UNITED STATES PATENT AND TRADEMARK OFFICE

APPLICATION NO.	FILING DATE	FIRST NAMED INVENTOR	ATTORNEY DOCKET NO.	CONFIRMATION NO.
10/814,597	04/01/2004	Jean-Pierre Rene Leon	403005/WEINSTEIN	5887
23548	7590	10/04/2005	EXAMINER	
LEYDIG VOIT & MAYER, LTD 700 THIRTEENTH ST. NW SUITE 300 WASHINGTON, DC 20005-3960			SHARP, JEFFREY ANDREW	
			ART UNIT	PAPER NUMBER
			3677

Office Action Summary

DETAILED ACTION

Leon et al WO-00/49299

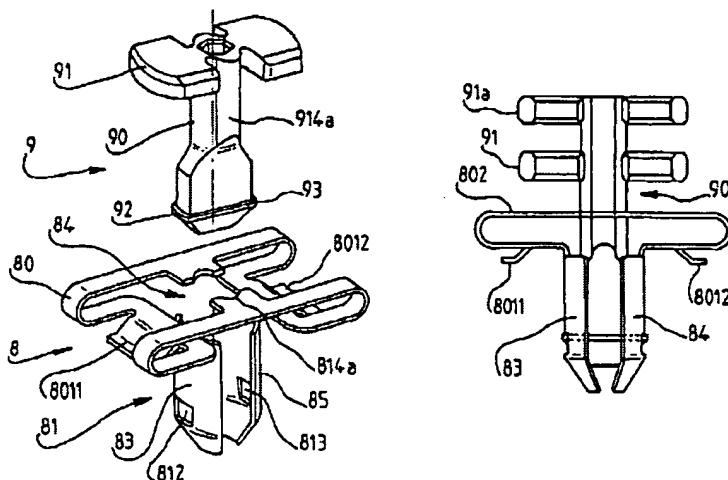
Leon et al. teach a female piece having a clasp, hollow elastically deflectable head, hollow foot portion having two tabs, and a male piece having a head (having a second head element (91), shaft, and cam portion. Broadly speaking, Leon et al. teach substantially all of the

claimed limitations, except for a **notch on the head** of the male piece that receives a **component** projecting from the head of the female piece -- said component comprising a resilient and axially-deflectable **finger** at its free end.

When construed broadly, the examiner maintains that the Leon et al. '299 reference suggests each and every limitation of claims 1-7, including the recited functional language and an immobilization element (91) on a male piece (90) comprising diametrically opposed portions/lateral protuberances which pass through a hollow (84) of the head (802) of the female piece (81).

Higdon et al. US-6,004,065

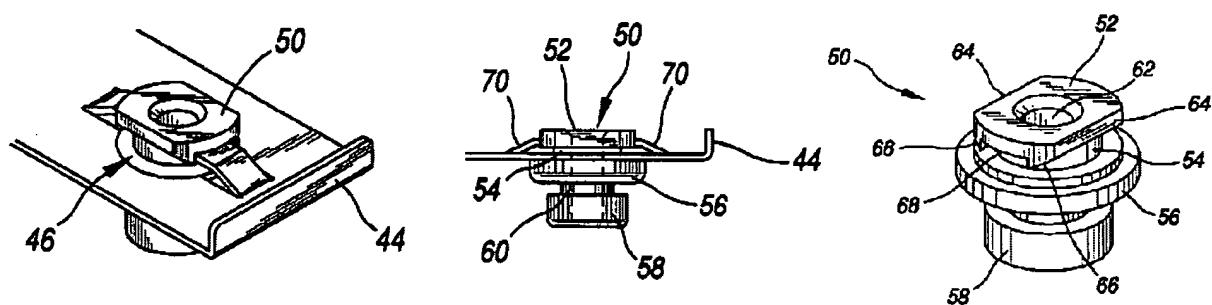
Higdon et al. teach a device for use in joining at least two panels together (Col 1 lines 7-9), comprising an anti-rotation apparatus. The anti-rotation apparatus has both *locked* and *unlocked* positions; both positions being facilitated by resilient, axially deflectable tab-like **components (70)** that extend from a female piece (30), and which have bent-like **finger portions** at their free ends. The fingers (70) are deflectable in an axial direction with respect to the shaft (54,60) axis of the male piece (50), and engage a **notch (68)** in the head (52) of the male piece (50), so as to prevent accidental rotation of the male piece (50) within the female piece (30). Accidental rotation of the male piece (50) is undesirable (as stated by Applicant in vibration environments), because it compromises the "separation of the tabs" and therefore threatens the "holding together a stack of panels". In order to achieve an *unlocked* position (i.e., position which allows rotation of the male piece (50) within the female piece (50)), the fingers (70) are axially deflected in between the two head portions (52, 56) and out of the notch (68) of the head (52). This is facilitated by cutouts (66), as Higdon et al. specifically disclose that clearance flats (i.e., "cutouts") are necessary for the first head portion (52) to clear the fingers (70) upon axial insertion of the male piece (50) into the female piece (30). See Higdon et al. Col 3 lines 26-38.

At the time of invention, it would have been obvious to one of ordinary skill in the art, to modify the fastening device taught by Leon et al., to comprise the anti-rotation device (i.e., 'resilient finger components' on a female piece, and a 'notch' on one of a plurality of head

elements on a male piece), as suggested by Higdon et al. and substantially discussed above, so as to prevent accidental rotation of the male piece within the female piece when the male piece is in a fully inserted position. Accidental rotation would undesirably cause loosening or separation of the panels.

Higdon et al. '065 suggests and makes obvious to one having an ordinary skill in the art, an improvement comprising providing at least one component/tab (70) which projects from a female piece (30) for fastening multiple panels (see title), said at least one component/tab (70) being engageable with at least one notch (68) in the periphery of the head (52) of a male piece (50).
